EVC OI.AC Alarm & Compressor Surging

This **Mandatory** service bulletin applies to all packaged Dx cooling or air-source heat pump units with inverter scroll compressors driven by EVC drives when the EVC drive has a firmware version of 1.54 or 1.57. These units are seeing periodic unexpected Oi.Ac alarms and occasional surging/revving conditions of the compressor at startup.

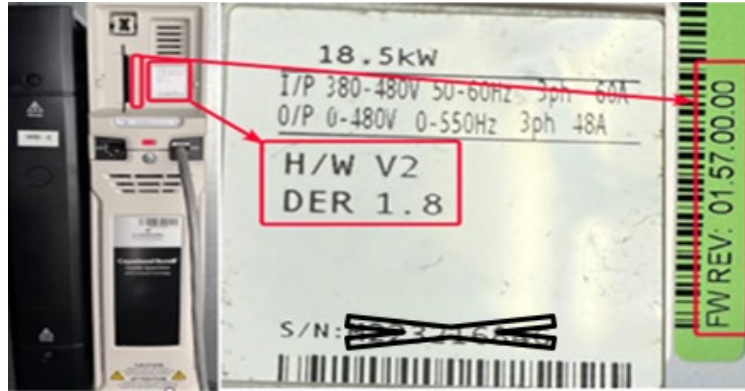
1. Check the EVC drive firmware version,
 - a. If a display is available.
 - i. Scroll to check parameter 00.077 – Make sure it is set to All menus
 - ii. Scroll to the right to find menu 11. Miscellaneous
 - iii. Scroll up to check parameter 11.029

- iv. If Software version is 01.57 or 01.54 a update is required
- b. If a display it not available check the firmware version using the label on the drive
 - i. If H/W V2 and DER 1.8 is printed on the rating label or FW REV: 01.57.00.00 is next to the rating label, the drive must be updated.

H/W V2 is **NOT** present or the derivate is DER 1.9 or DER 1.10, the firmware on that drive does **NOT** need to be updated.
